REMARKS

AMENDMENTS TO THE DRAWINGS

The attached sheets of drawings includes changes to Figures 4, 5 and 6.

FIG. 4

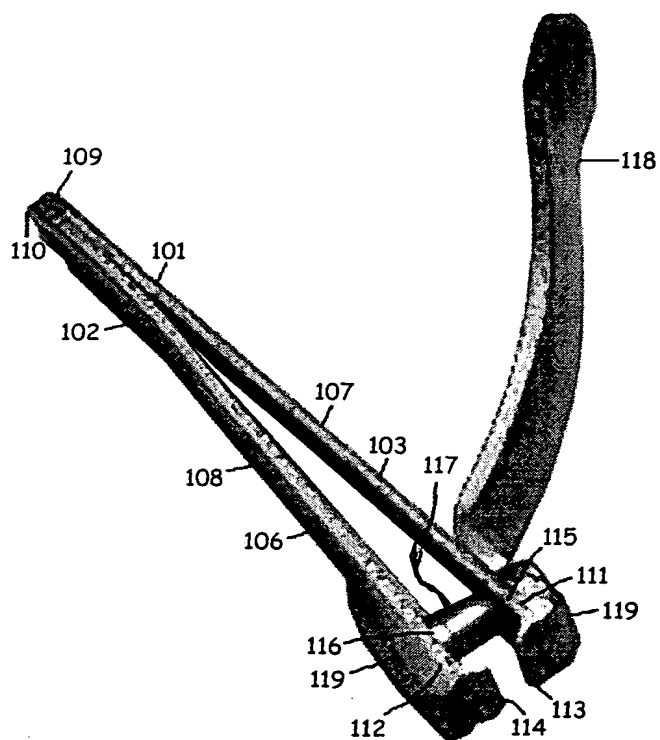
The objection to the drawings is respectfully traversed. It is respectfully pointed that the interconnection between the top and bottom members is shown in Figure 4. As stated on page 3, lines 13-14 of the application, distal ends 109, 110 of the elongated members 101, 102 are interconnected in any convenient fashion. The same figure also shows a post extending from the bottom member 102 to the top member 101. Figure 6 shows a thumb accepting depression 121. With respect to claim 8, the term "offset" was not totally appropriate and more accurately it should have been stated (and the claims have now been amended to state) that the cutting edges are at an angle to the central longitudinal axis of the members. This is shown in Figure 6 and can also be seen Figure 5.

Upon review of the drawings, it has been recognized that the lead line to post 117 in Figure 4 was incomplete, the post was not labeled in Figure 5, and a wrong numeral was used in Figure 6. Corrected drawings are being submitted for entry after approval of the Examiner.

The objection to the specification is respectfully traversed. The structure of the clipper in Figure 5 is clearly described. The top and bottom members are interconnected, albeit not at the distal end as in Figure 4, and there is a post extending from the top surface of the bottom member to above the top surface of the top member, albeit not through an opening in the top member as shown in Figure 4.
